# Elizabeth Drive East Upgrade

## Submissions Report

October 2024

Figure 4-2: Property acquisition and temporary leases for the proposal – sheet 2 of 4 (update to Figure 3-26 of the REF)

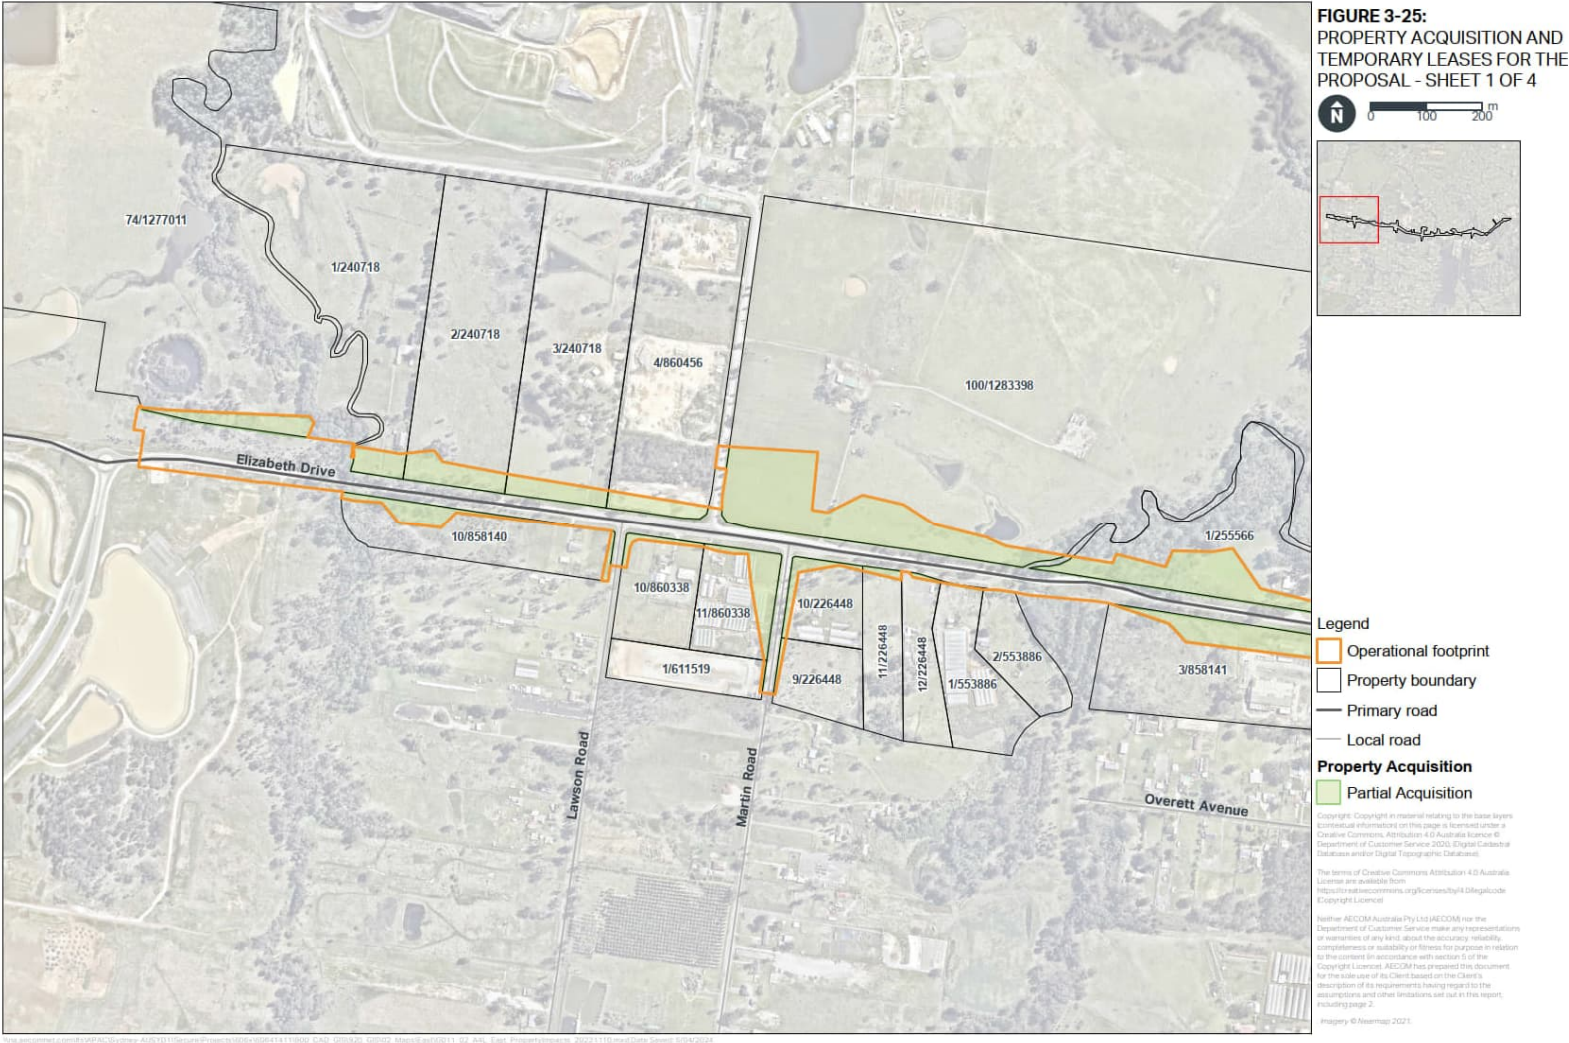
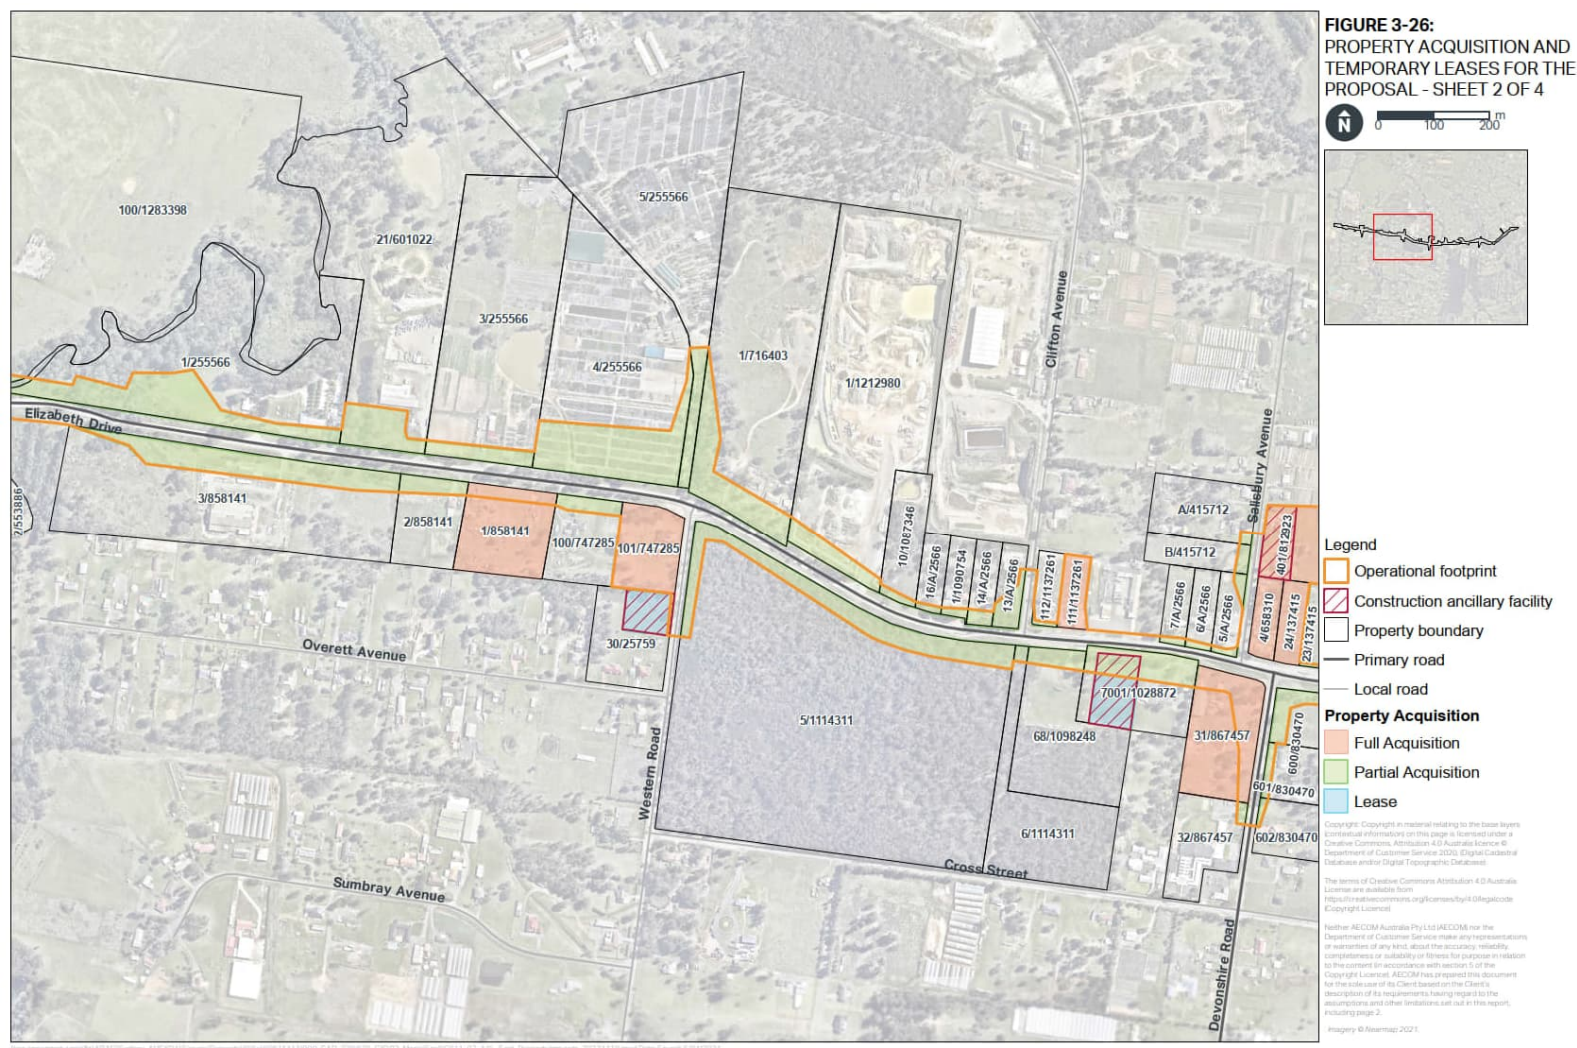
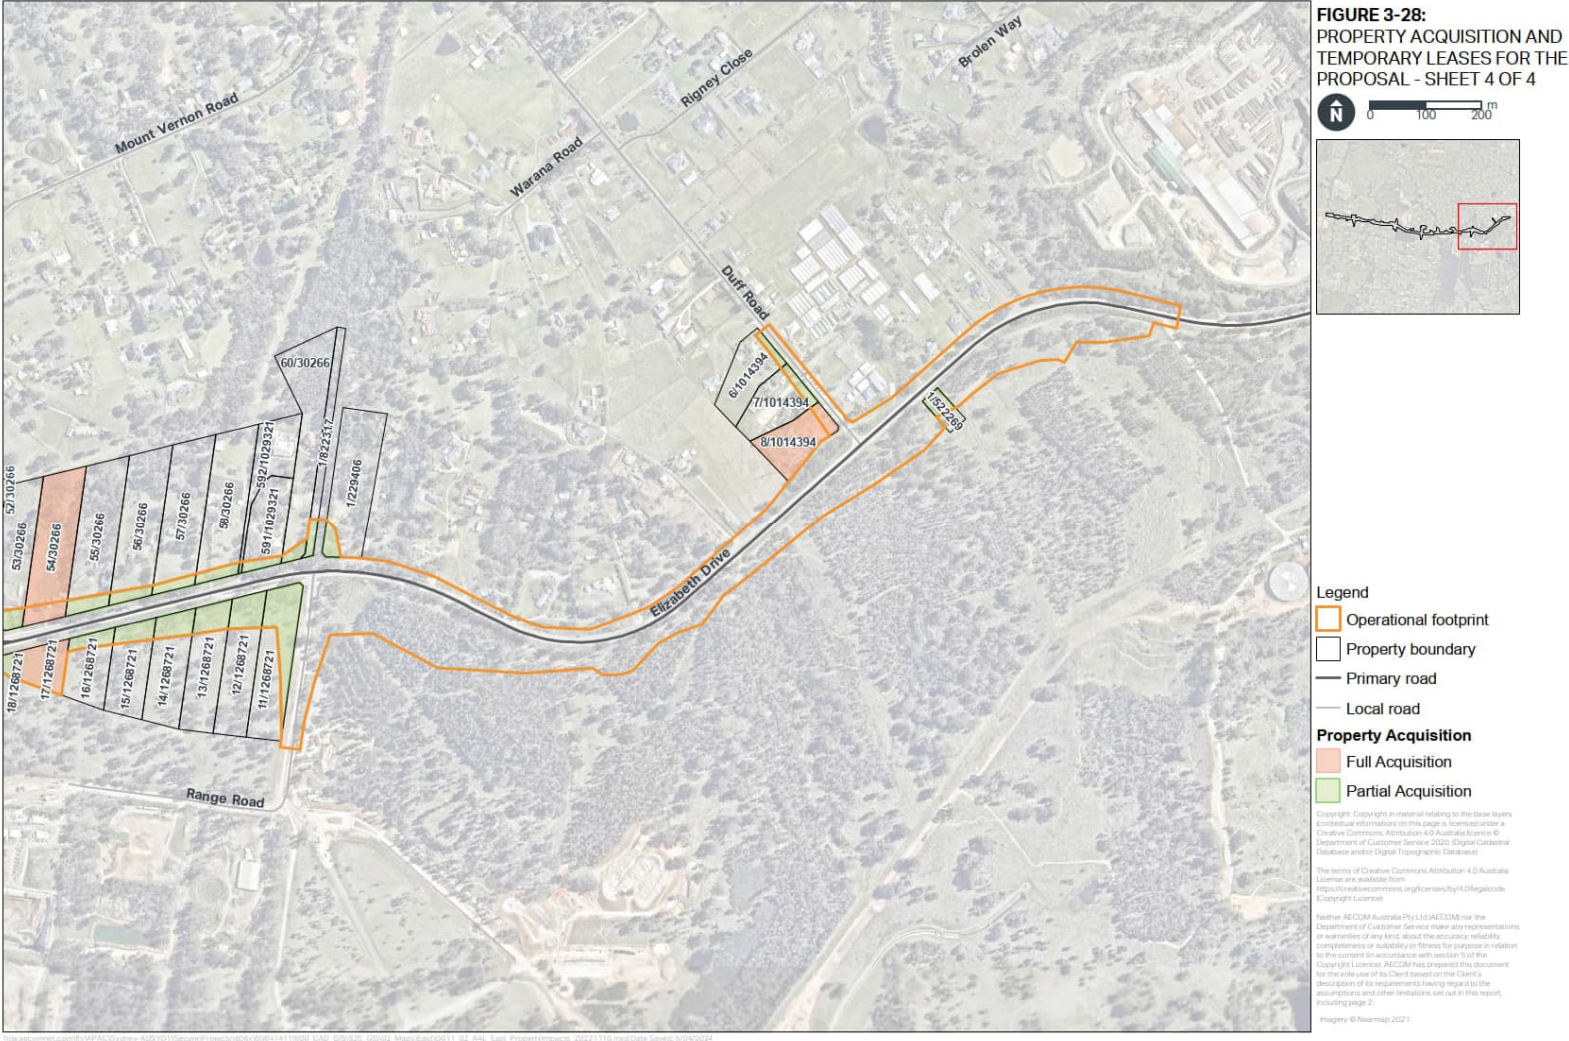
Details of the changes to proposed property acquisition since the finalisation of the REF are provided in Table 4-1. Figures 3-25 to 3-28 of the REF have been reproduced as Figure 4-1 to Figure 4-4, inclusive of the changes to property acquisition. These figures have also been updated to include cadastral information (property boundaries) from 2024.

Property acquisition extents shown on Figure 4-1 to Figure 4-4 are based on the concept design for the proposal. Prior to acquisition of these properties, their cadastral boundaries would be reviewed and confirmed, including via survey.
